# HISTORIC AND DESIGN REVIEW COMMISSION

**HDRC CASE NO:** 2023-268  
**ADDRESS:** 814 N OLIVE ST  
**LEGAL DESCRIPTION:** NCB 540 (GREENVIEW PLACE), BLOCK 11 LOT 21  
**ZONING:** RM-4, H  
**CITY COUNCIL DIST.:** 2  
**DISTRICT:** Dignowity Hill Historic District  
**APPLICANT:** Brad Clawson/Elise Construction  
**OWNER:** Brad Clawson/Elise Construction  
**TYPE OF WORK:** Amendment to previously-approved design for new construction of three two-story residences  
**APPLICATION RECEIVED:** June 01, 2023  
**60-DAY REVIEW:** July 31, 2023  
**CASE MANAGER:** Jessica Anderson

The applicant requests a Certificate of Appropriateness for approval to amend a previous approval to construct three two-story structures on the vacant lot addressed 814 N Olive, formerly addressed 810 N Olive, specifically to:

EXT  
ELEVATIONS -  
814 N OLIVE -  
BLDG C&E

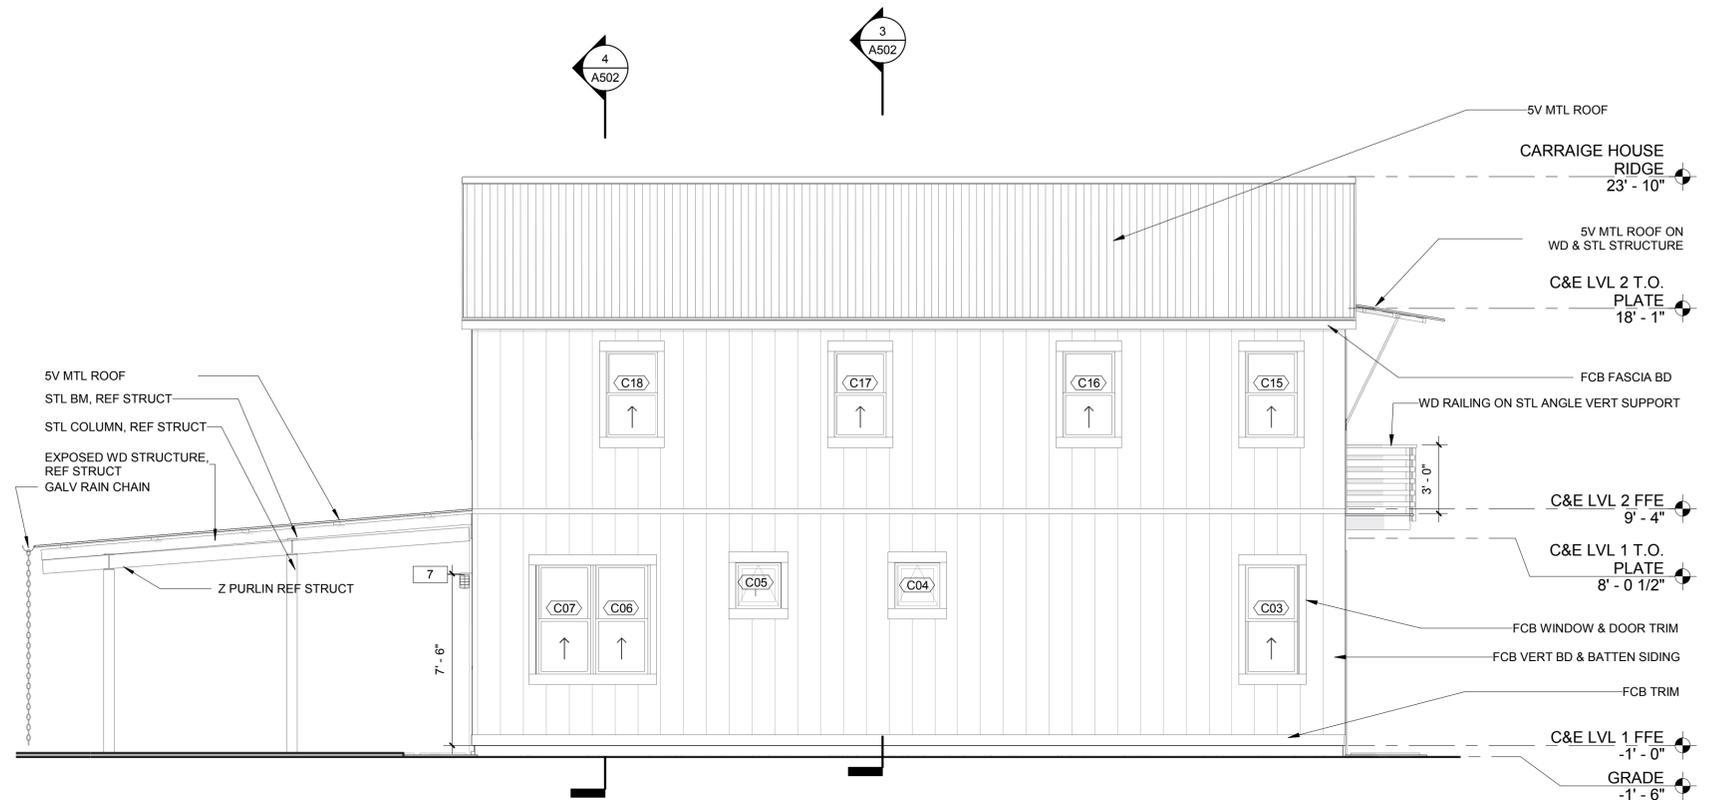
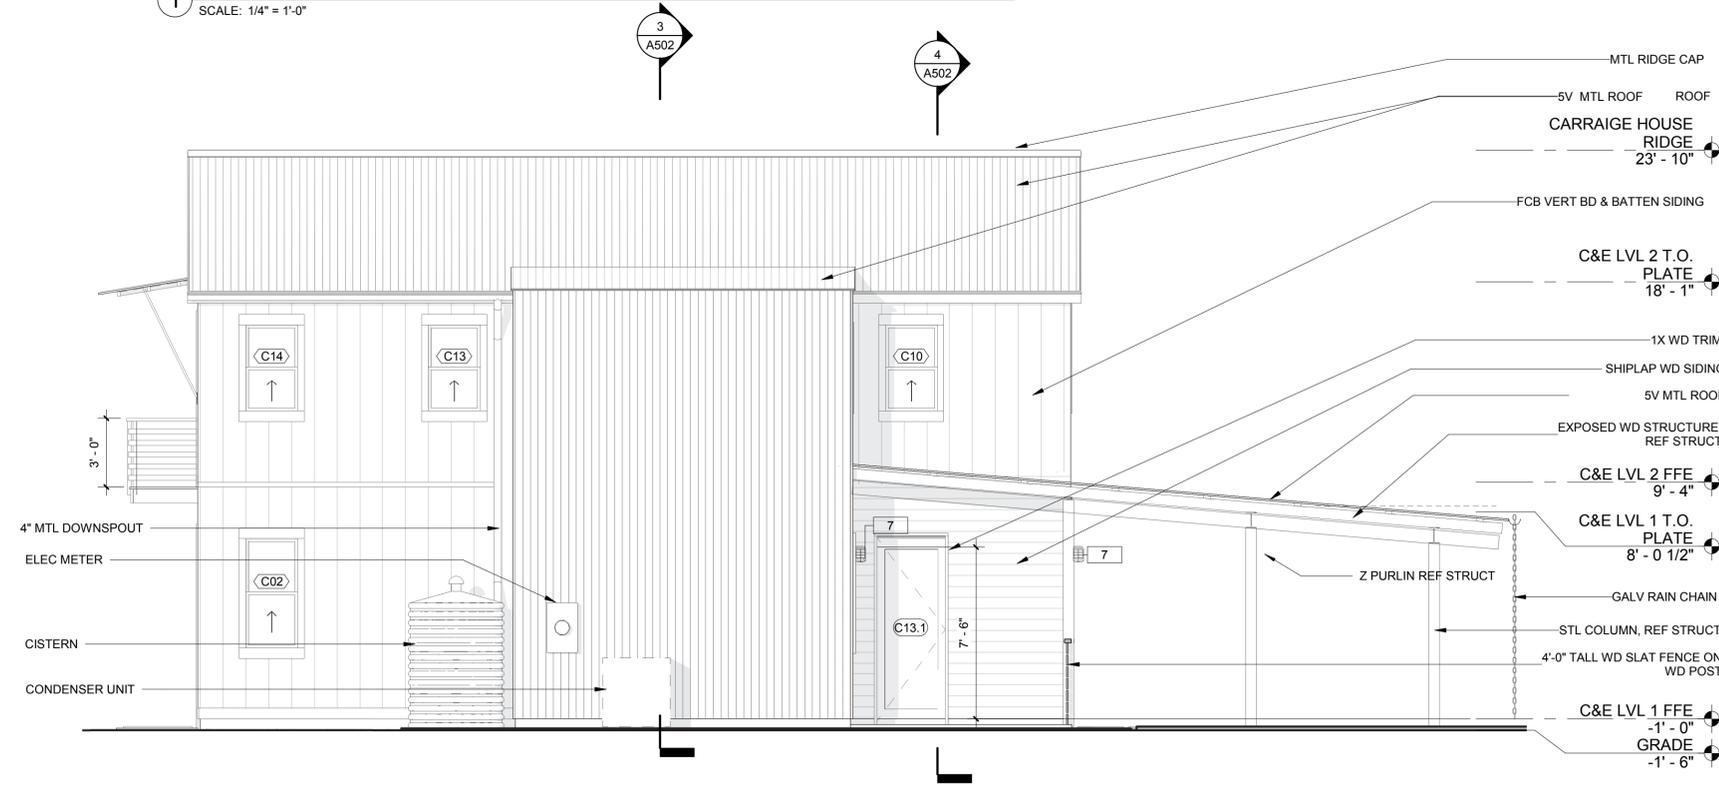
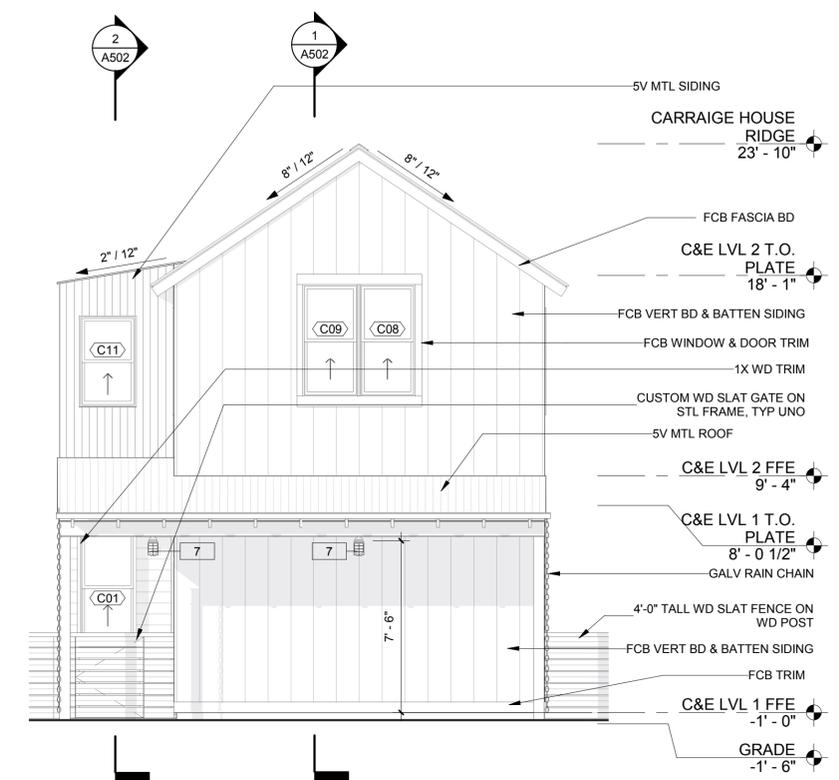
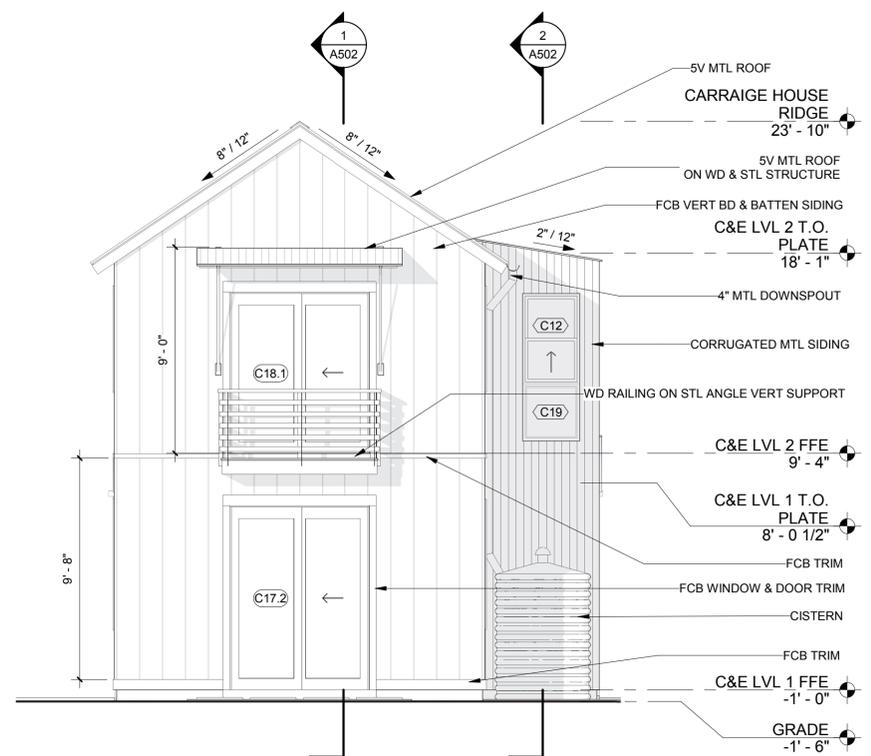
- e. **WINDOWS (MATERIALS):** The applicant requests to install aluminum windows on all three structures; the HDRC previously approved fiberglass-clad wood windows, which are still reflected on the most recent plans

- ii. That the applicant installs a standing seam metal roofs on all three structures, as noted in finding d. The roofs should feature panels that are 18 to 21 inches wide, seams that are 1 to 2 inches high, a crimped ridge seam, and match the current finish or a standard galvalume finish. Panels should be smooth without striation or corrugation. Ridges are to feature a double-munch or crimped ridge configuration; no vented ridge caps or end caps are allowed. An inspection must be scheduled with OHP staff prior to the start of work to verify that the roofing material matches the approved specifications. No modifications to the roof pitch or roof form are requested or approved at this time.
